amac	**HAN-500_MAIN**		
Title	**02.Main Power**		
Size A4	Document Number	Edited By **Jinny Kim**	Rev **MD**
Date: Tuesday, June 29, 2004	Sheet 2 of 6

04.Flash Memory, Connector

HAN-500_LCD

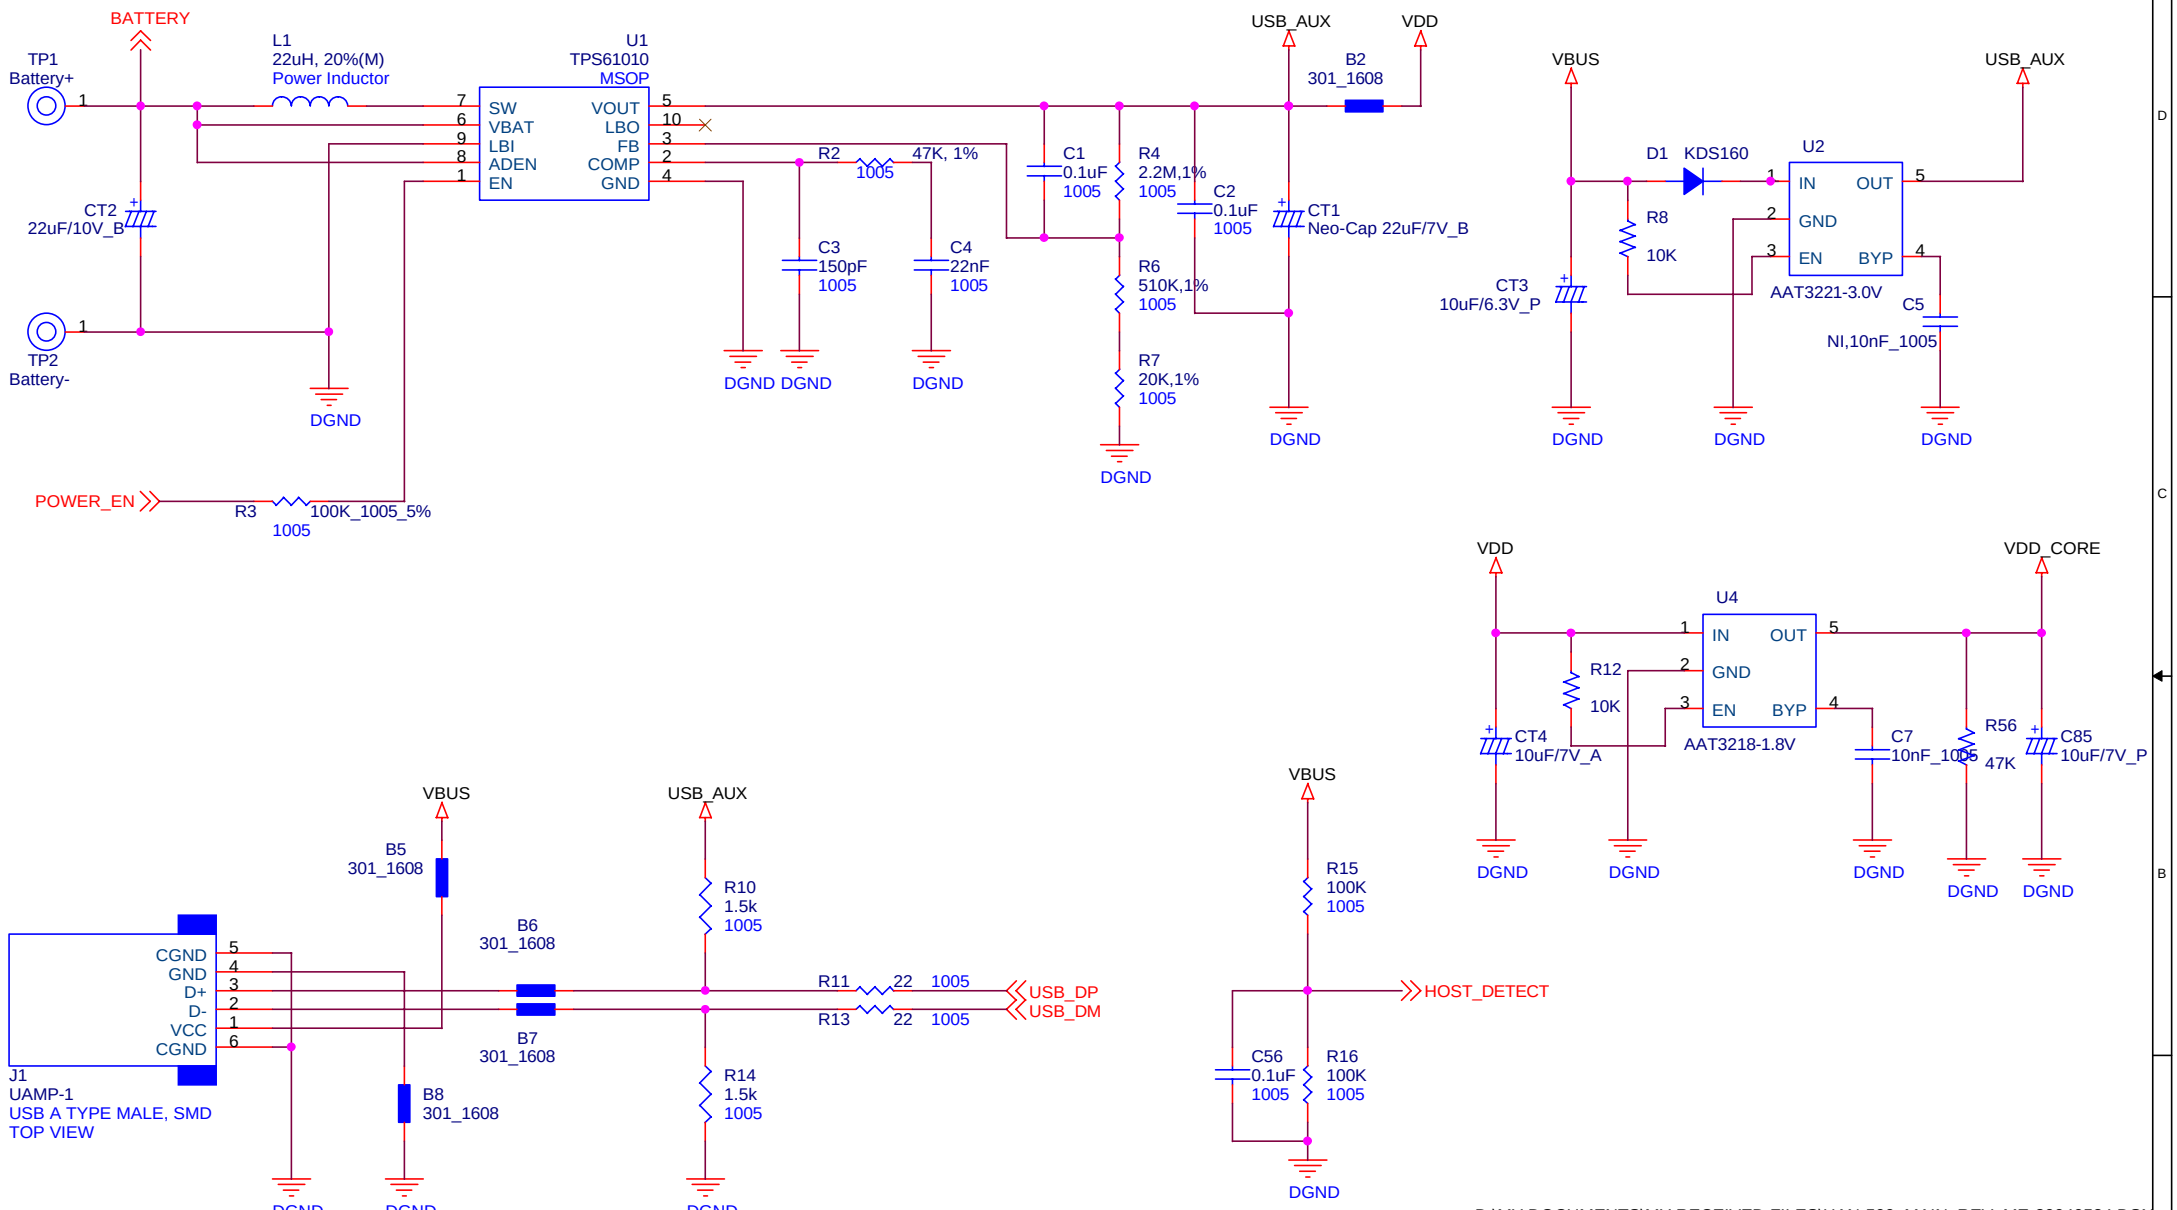
R87삭제

5번핀 DGND

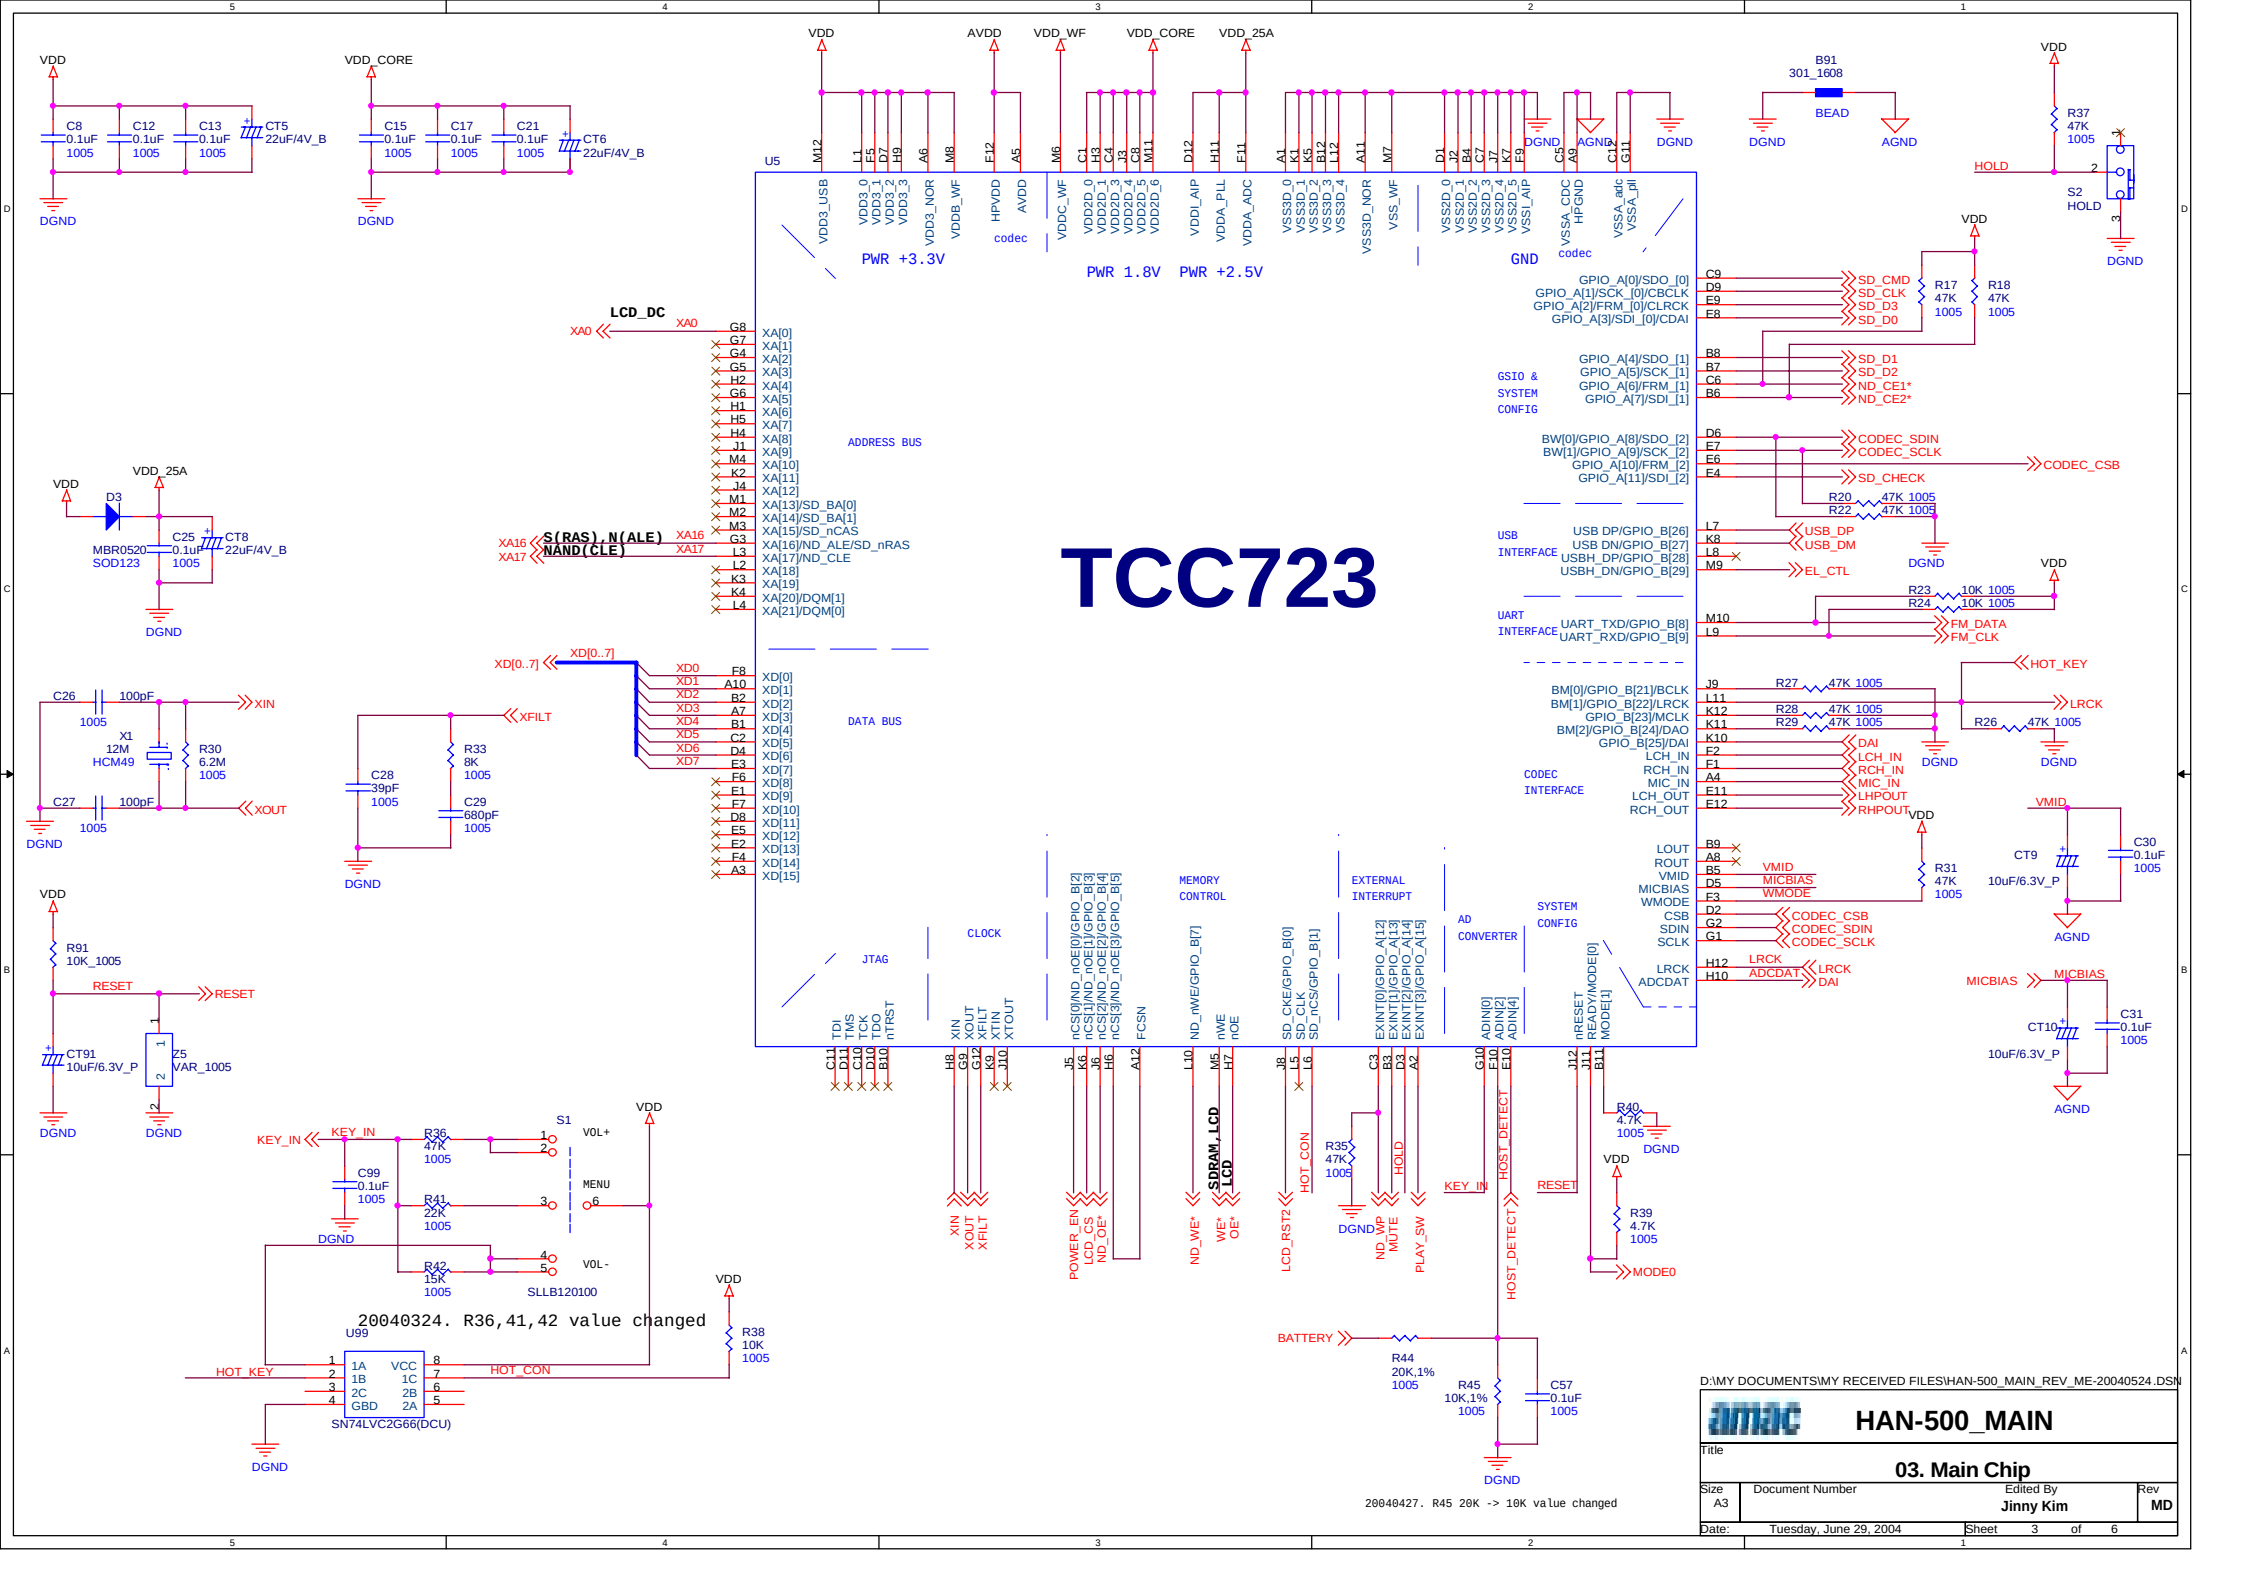
FLASH K9W4G08__
-->R92,R93적용

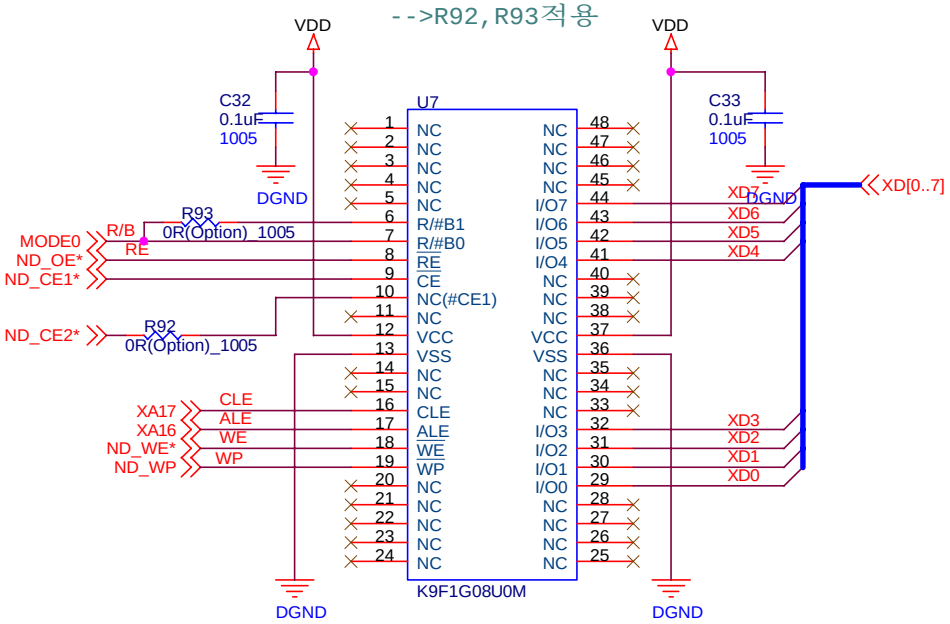
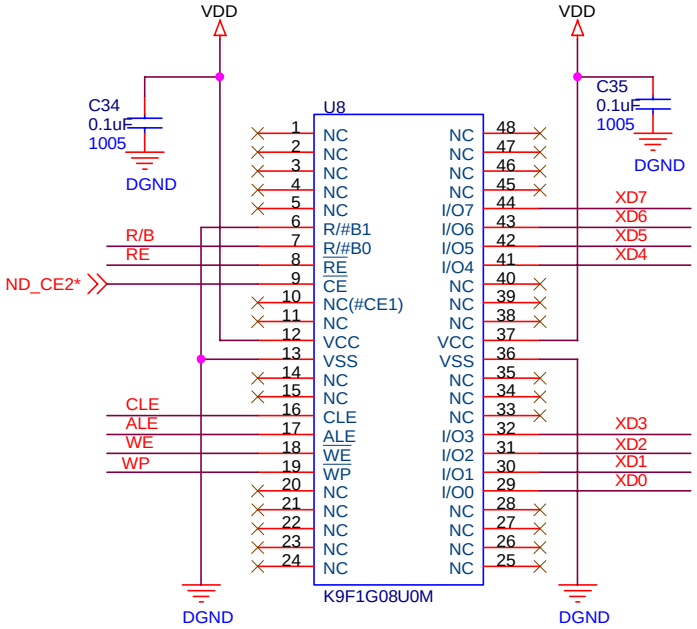
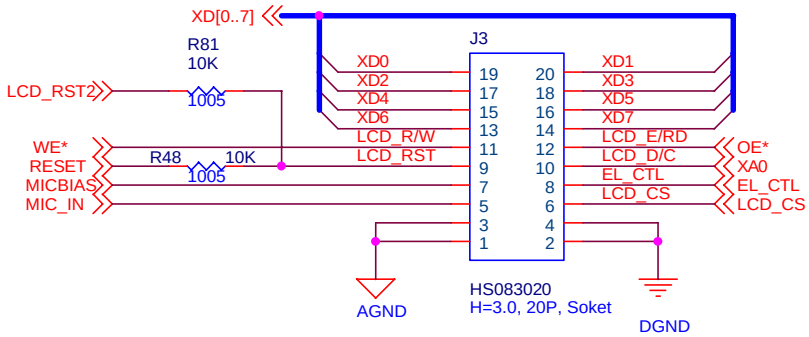
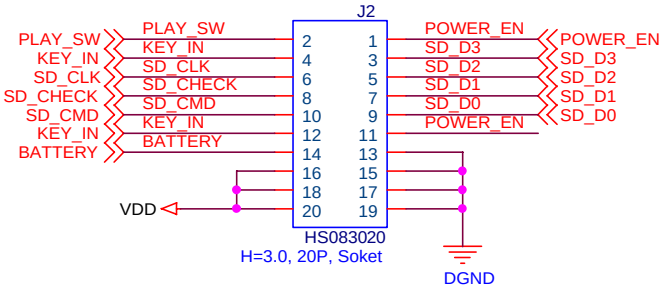
R81 상판과 이중으로 잡혀 있음.

20040427. J3 20핀으로 변경
